Item Name: Crosstube Turning Detail

DART AEROSPACE LTD		Work Order:	97086
Description: Crosstube Assembly (412 Low Aft)		Part Number:	D412-664-249
Inspection Dwg: D412-664-249 Rev: B		Page 1 of 2

DRAWING NO. D412-664-249	TITLE CROSSTUBE ASS'Y (412 LOW AFT)	REV. B	DART AEROSPACE LTD ENGINEERING ORDER		D.E.O. NO. D412-664-249-B-1	SHEET NO. SHEET 1 OF 2	SCALE NTS
DRAWN <i>q</i>	CHECKED <i>Sc</i>	MFG. APPR. <i>E</i>	APPROVED <i>MD</i>		DE APPR. <i>MD</i>		
DATE 11.05.25	DATE 11.05.31	DATE 11.05.31	DATE 11/05/31		DATE 11.05.31

DRAWING NO. D412-664-249	TITLE CROSSTUBE (412 LOW AFT)	REV. B	DART AEROSPACE LTD ENGINEERING ORDER		D.E.O. NO. D412-664-249-B-3	SHEET NO. SHEET 1 OF 3	SCALE NTS
DRAWN 47	CHECKED J	MFG. APPR. D	APPROVED 140		DE APPR. H		
DATE 12.08.21	DATE 12.08.30	DATE 12.08.30	DATE 12.08.30		DATE 12.08.30

D412-664-249
ASSEMBLY DETAIL

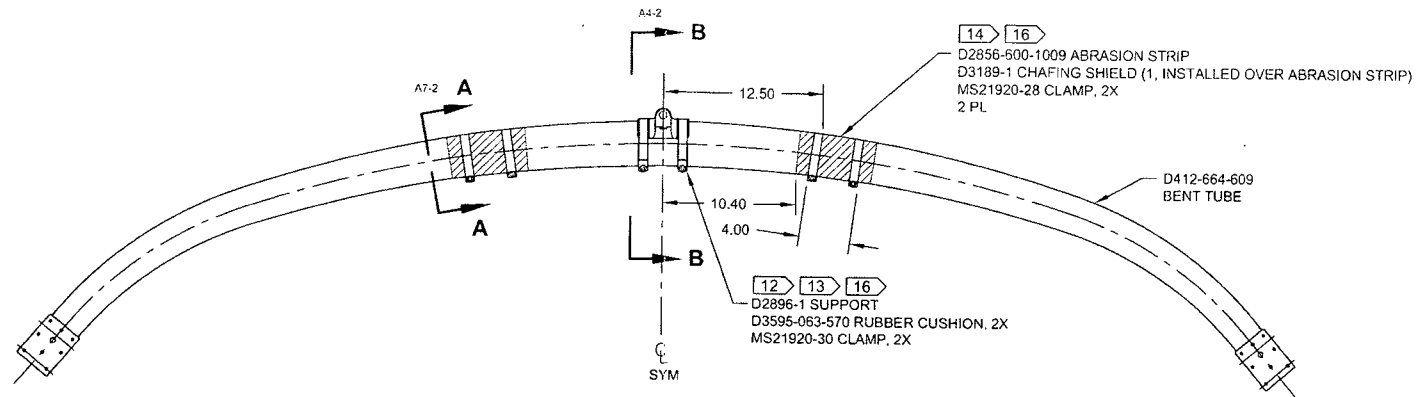
REMOVED ABRASION STRIP IN FAVOR OF A THIN LAYER OF PROSEAL 890.

IS:

16 14
 D3189-1 CHAFING SHIELD (1, INSTALLED OVER PROSEAL 890)
 MS21920-28 CLAMP, 2X
 2 PL

WAS:

14 16
 D2856-600-1009 ABRASION STRIP
 D3189-1 CHAFING SHIELD (1, INSTALLED OVER ABRASION STRIP)
 MS21920-28 CLAMP, 2X
 2 PL

**D412-664-249
ASSEMBLY DETAIL**

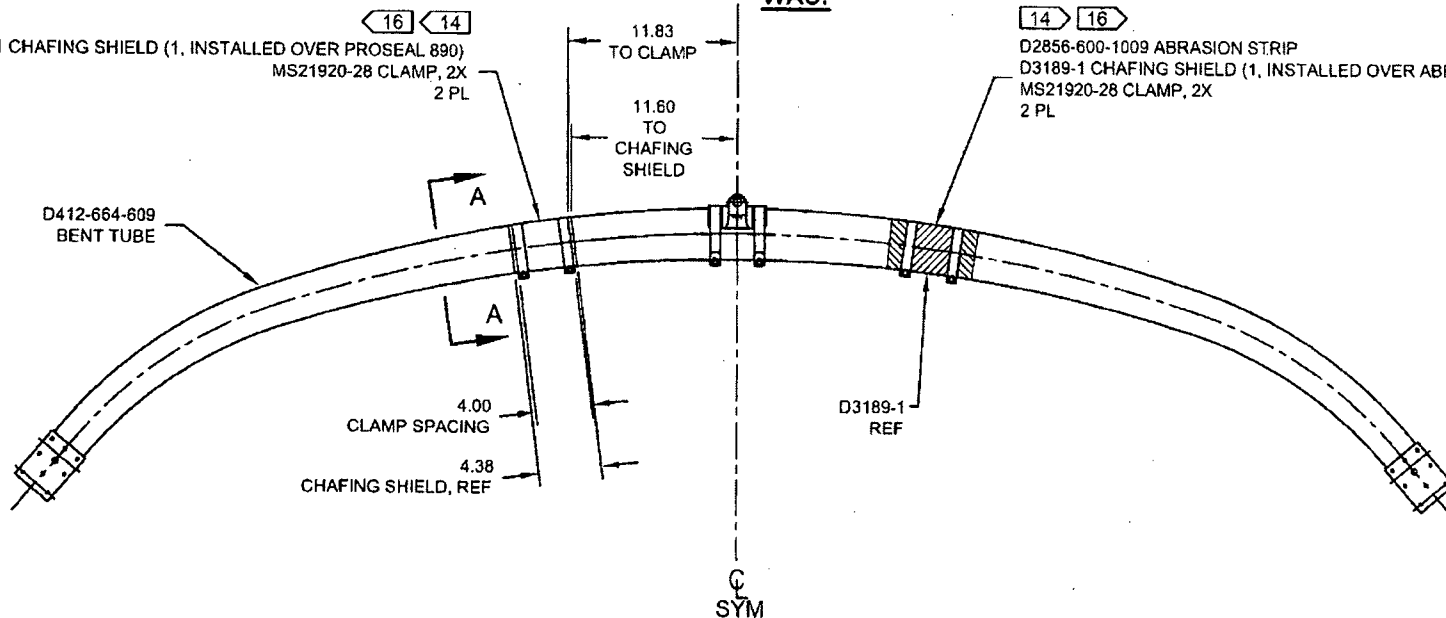
REMOVED ABRASION STRIP IN FAVOR OF A THIN LAYER OF PROSEAL 890. UPDATE INSTALLATION OF CHAFING SHIELDS AND REDUCE TORQUE TO 40-50 IN-LBS. THIS ENGINEERING ORDER SUPERCEDES DEO D412-664-249-B-1

IS:

D3189-1 CHAFING SHIELD (1, INSTALLED OVER PROSEAL 890)
MS21920-28 CLAMP, 2X
2 PL

WAS:

D2856-600-1009 ABRASION STRIP
D3189-1 CHAFING SHIELD (1, INSTALLED OVER ABRASION STRIP)
MS21920-28 CLAMP, 2X
2 PL

SECTION A-A
CHAFING SHIELD DETAIL
VIEW ROTATED, NOT TO SCALE

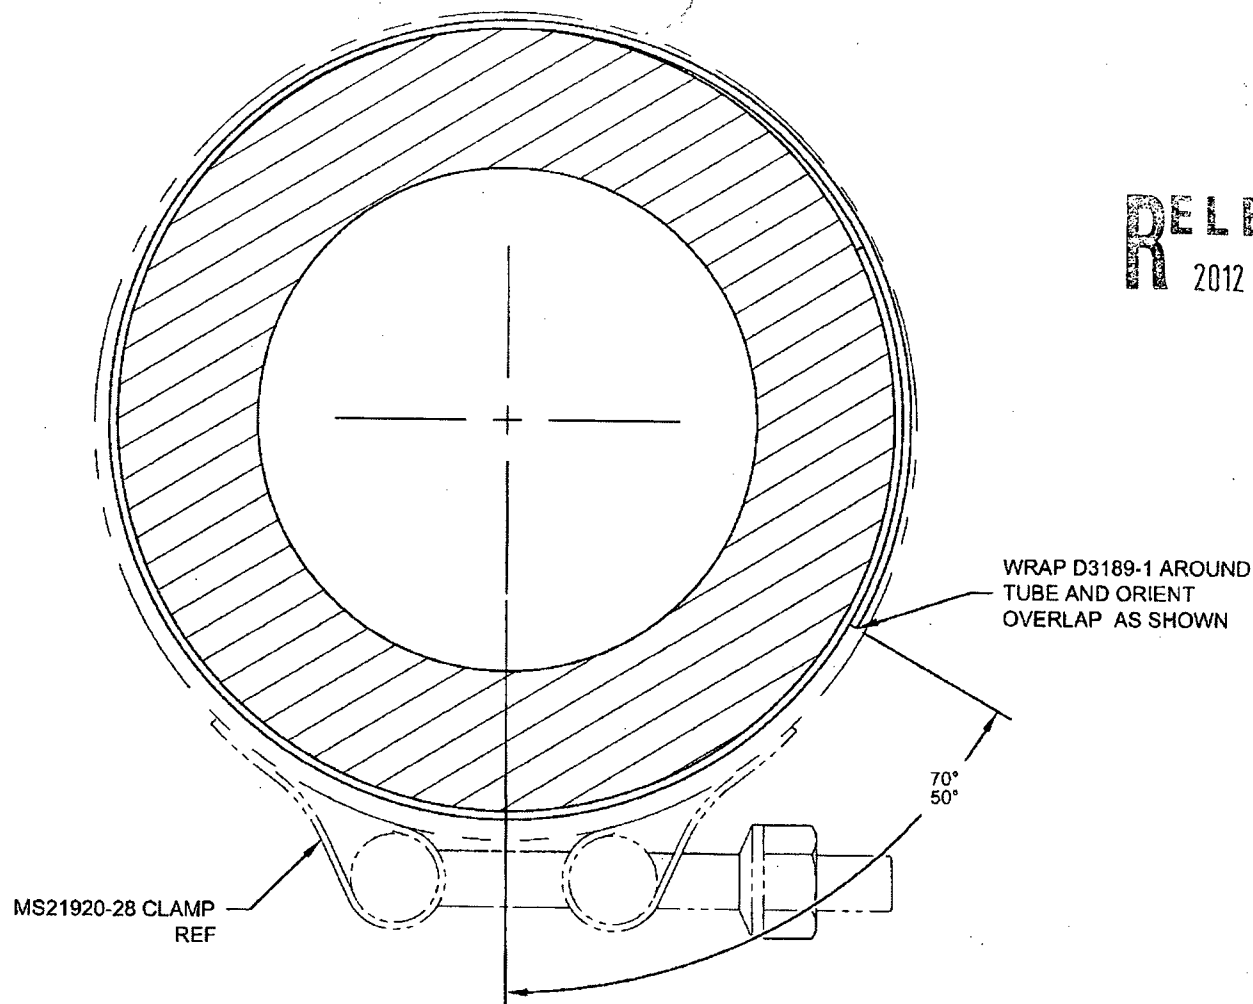
- 14) APPLY A THIN COAT OF PROSEAL 890 ON INSIDE CONCAVE SURFACE OF D3189-1 CHAFING SHIELD AND LET CURE PER MANUFACTURER'S INSTRUCTIONS. INSTALL PROSEALED D3189-1 CHAFING SHIELD ONTO CROSSTUBE BY APPLYING A THIN COAT OF PROSEAL 890 ONTO CROSSTUBE. BE SURE TO ELIMINATE ANY AIR GAPS.
- 16) TORQUE CLAMPS ON D2896-1 SUPPORT 80 TO 100 IN-LB. **TORQUE CLAMPS ON D3189-1 CHAFING SHIELD 40 TO 50 IN-LB.** ENSURE AT LEAST 1.5 THREADS SHOWING IN SAFETY AND THAT NUT HAS NOT BOTTOMED-OUT AFTER TORQUING.
